8-10 New McLean Street

Proponent Response Proposal

Prepared for
DPHI

Issued
July 12 2024

Envelope & Controls

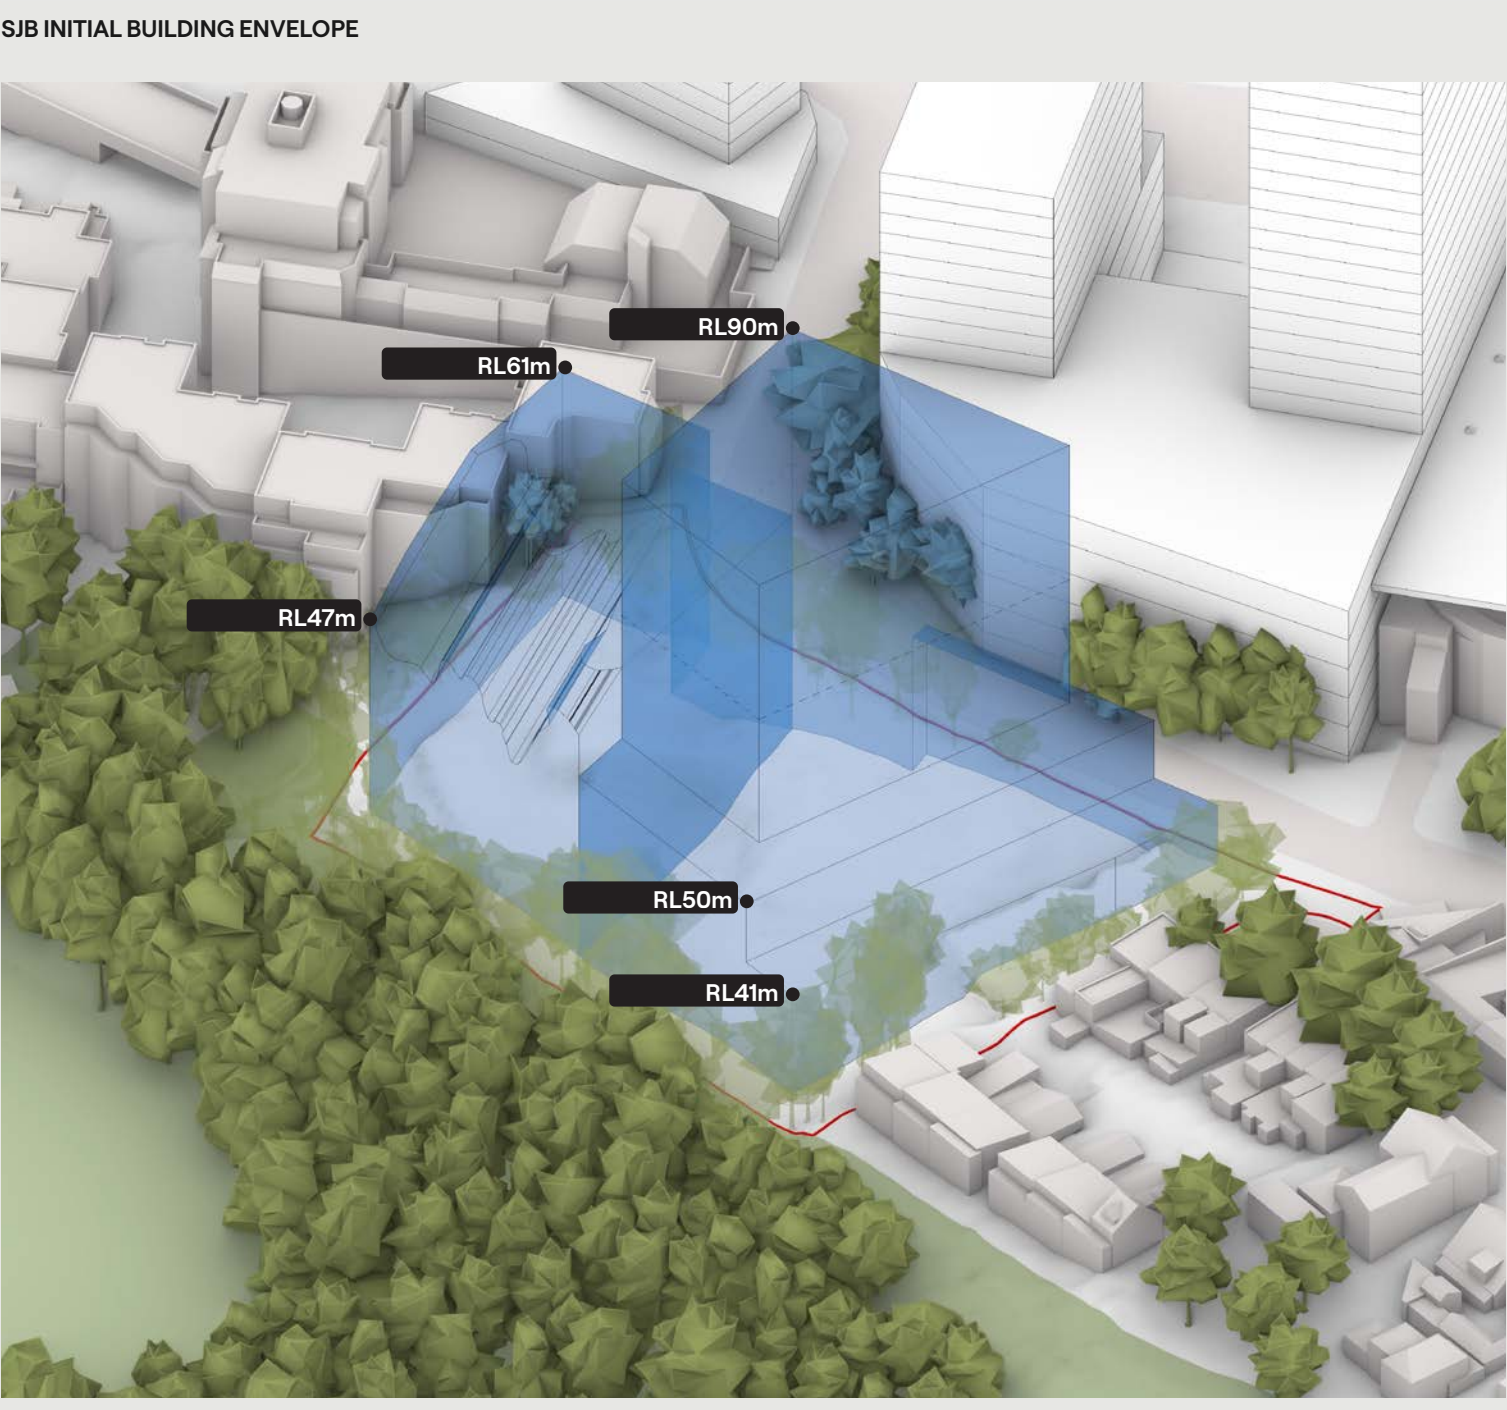
The Proponent response includes decreased setbacks along the southern and western boundary along with an extension of the envelope to capture the interface with the terraces to the east.

The overall height is also proposed to increase which could technically accommodate 19 storeys, as opposed to the recommended 18. Some minor changes have also been proposed to increase heights to accommodate BCA/NCC requirement.

PROPONENT RESPONSE

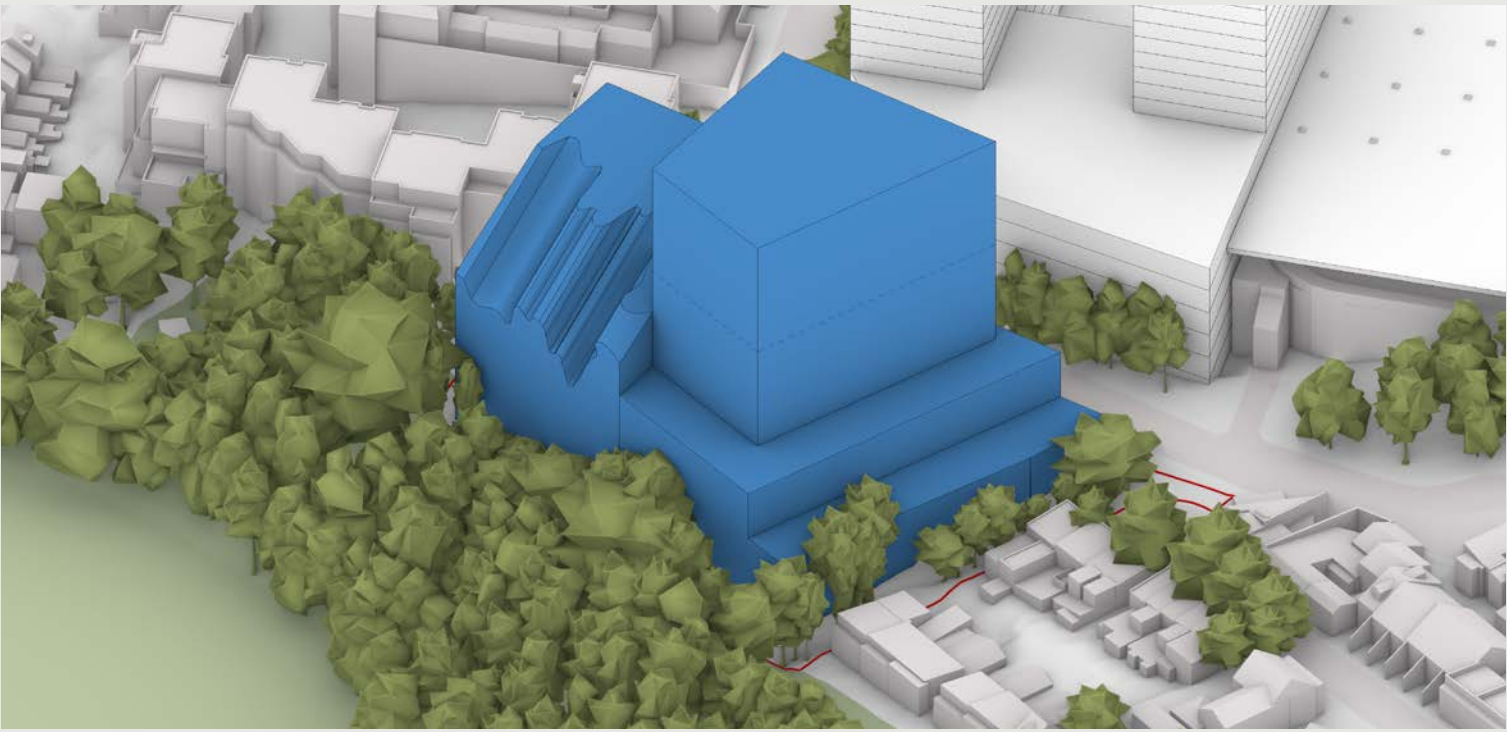
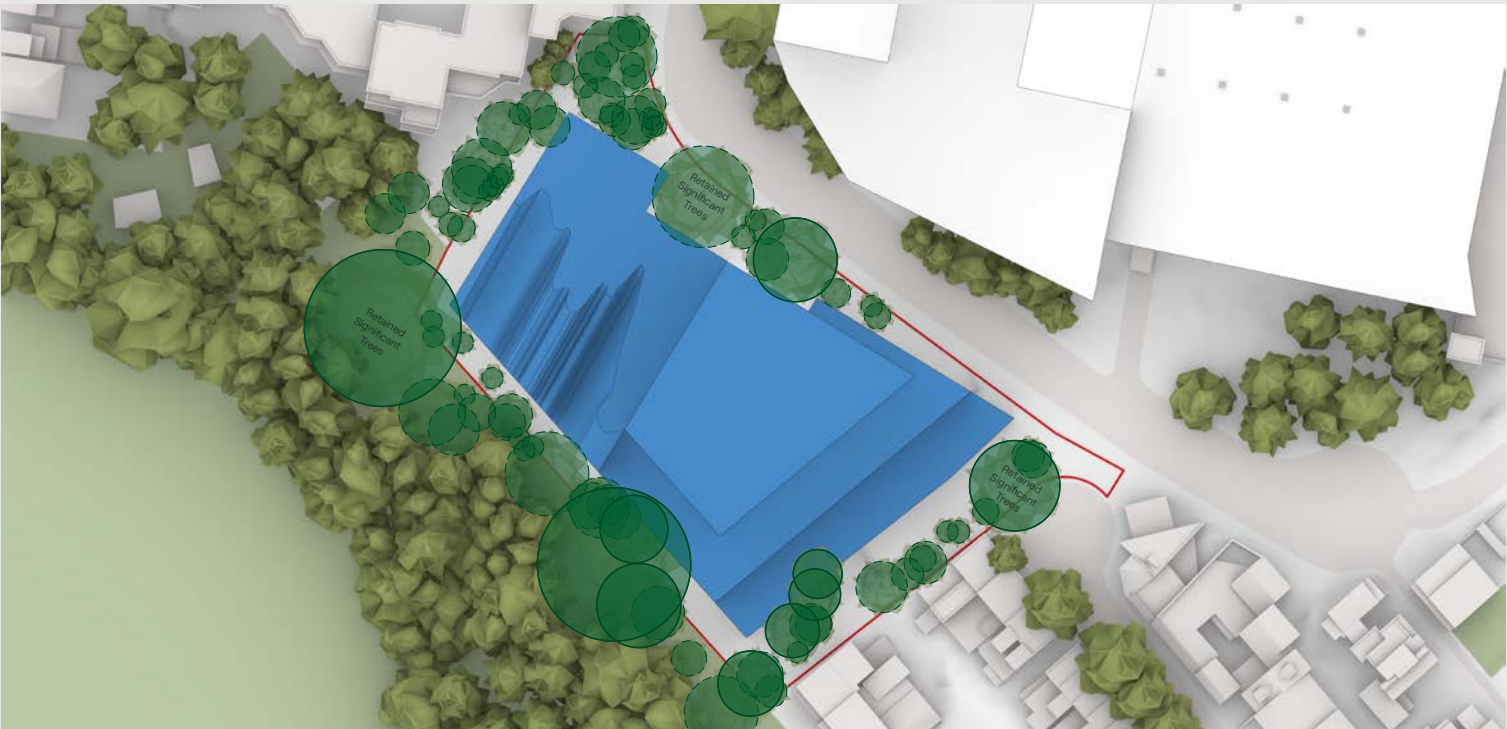
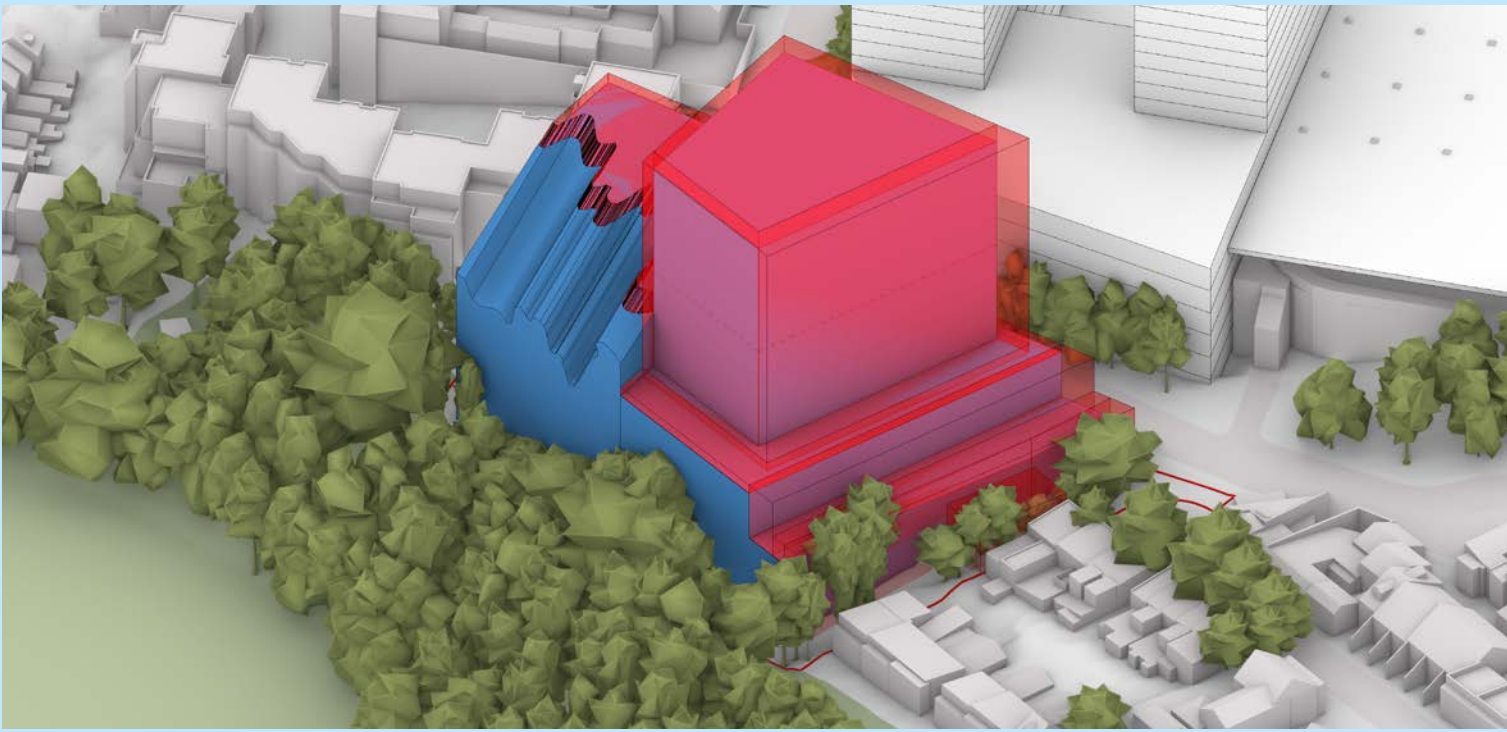
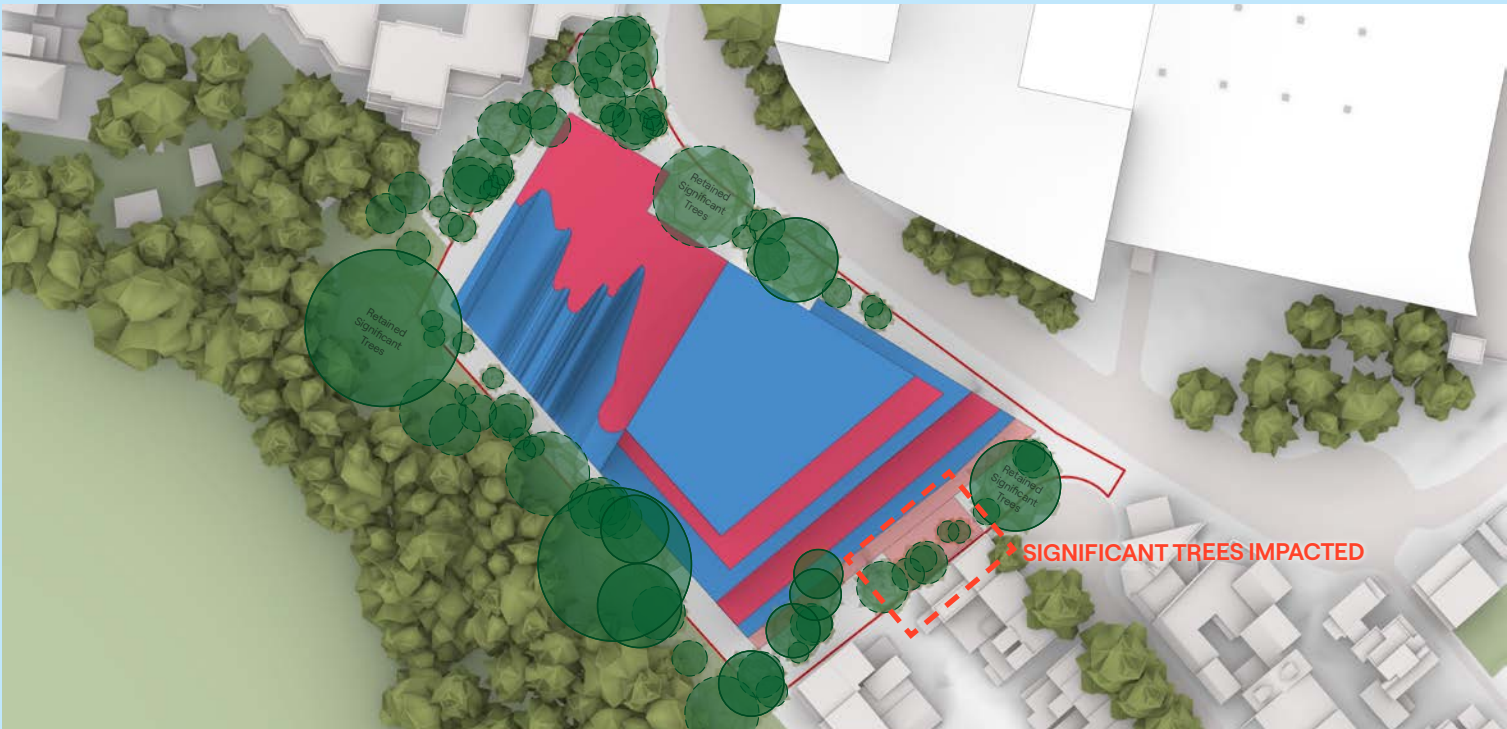
The increased envelope would also impact biodiversity and the retention of some significant trees on the periphery of the site.

Visual Impact

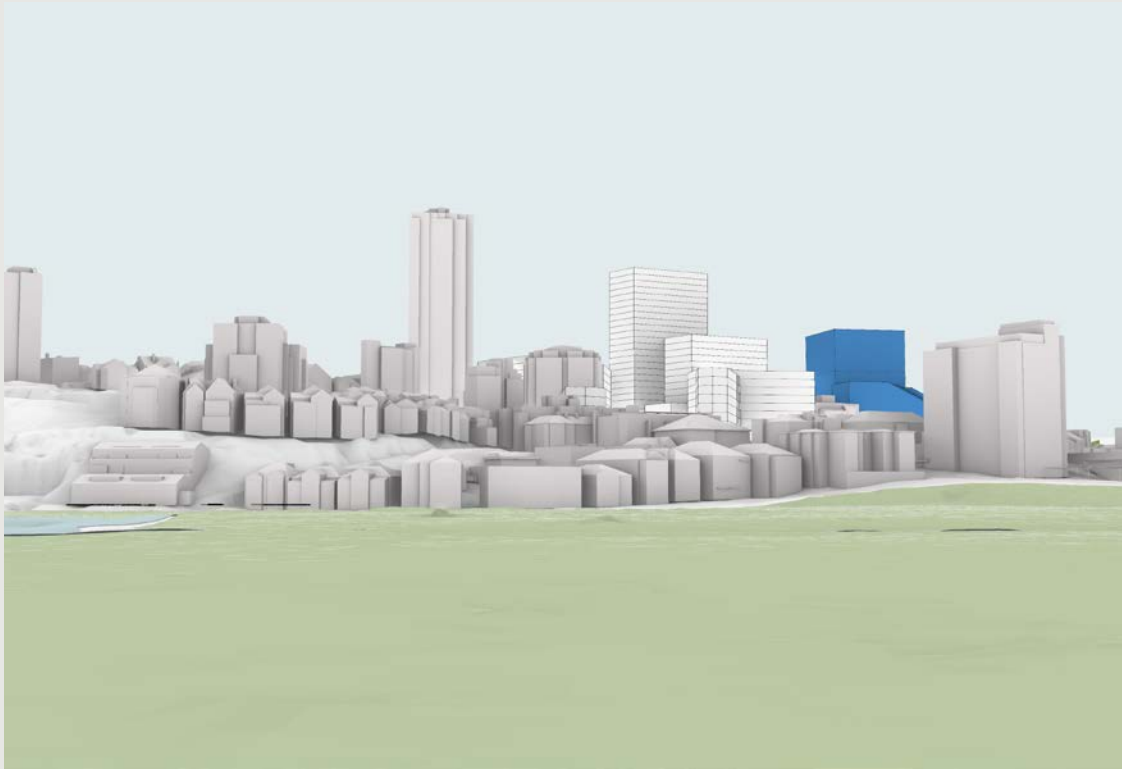
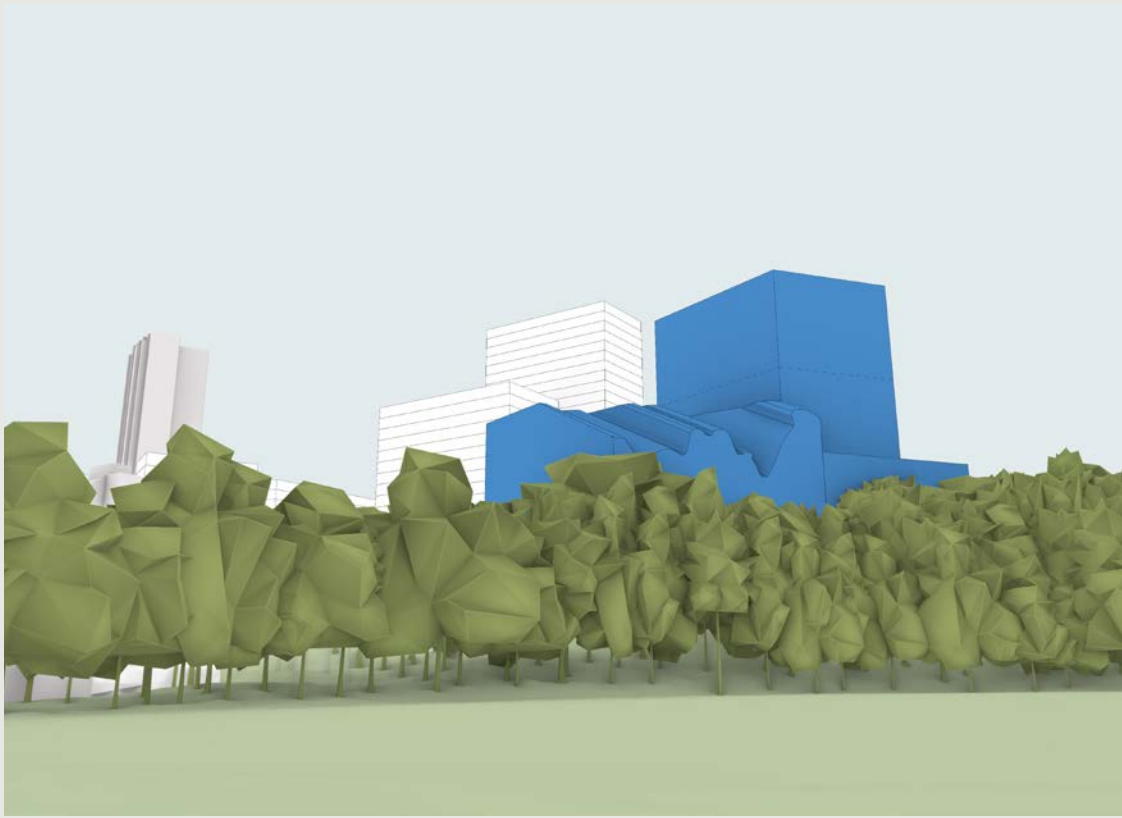
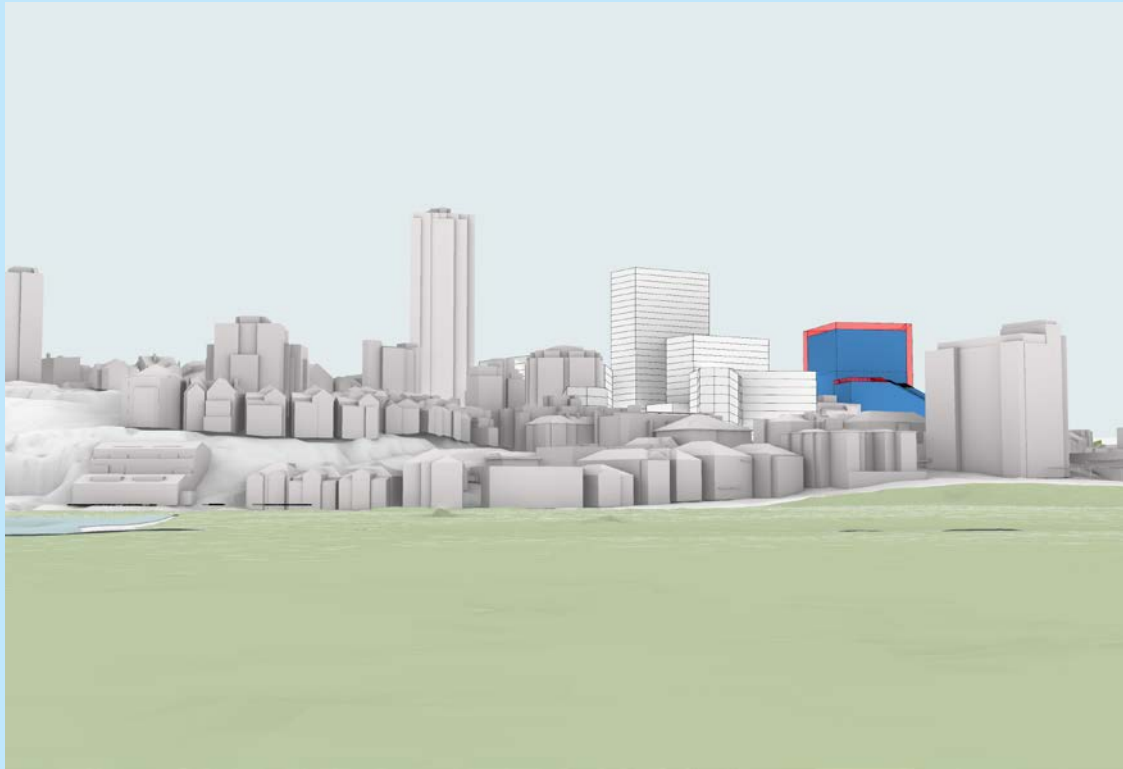
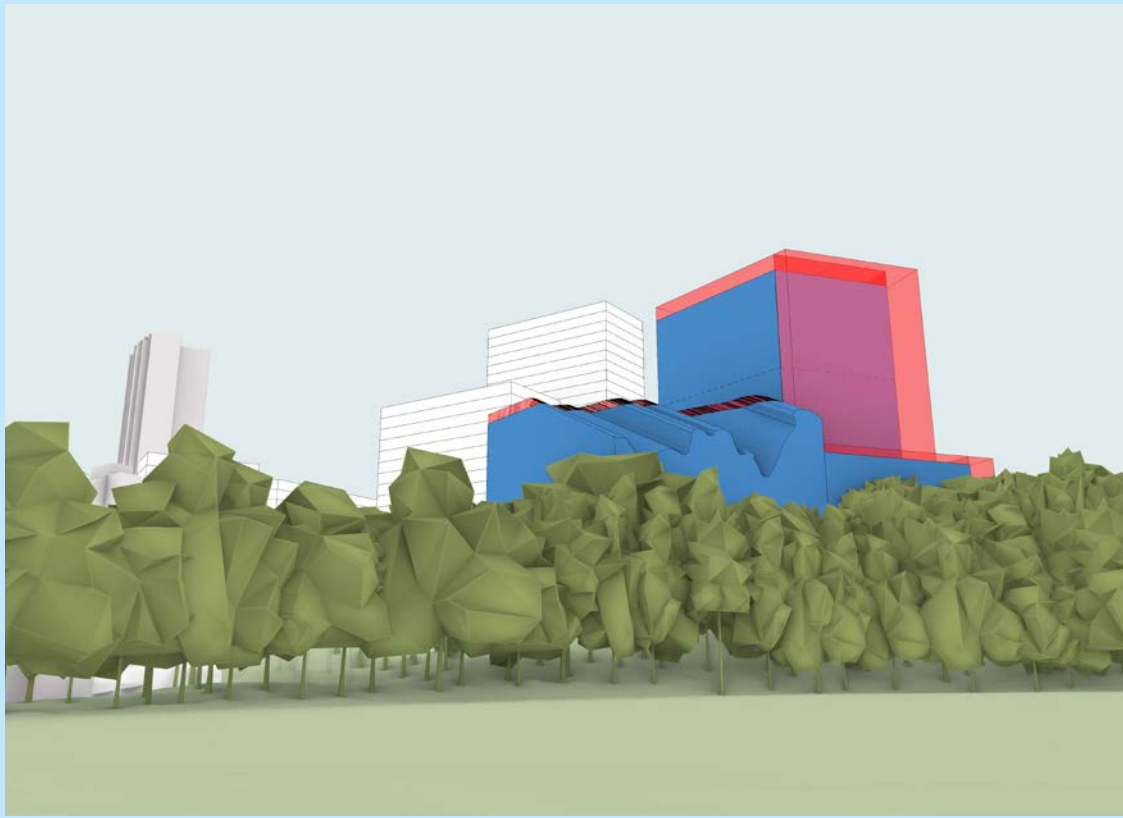
The increase in tower footprint in the Proponent’s responding envelope demonstrates a significant increase in bulk, increasing the overall visual impact.

In particular, the increase in envelope bulk as seen from Trumper Oval results in an inadequate transition in height and scale with the ECC. The extensions to the podium on the eastern boundary and increases in podium heights to accommodate terrace floor-to-floor heights is not seen to impact from these views.
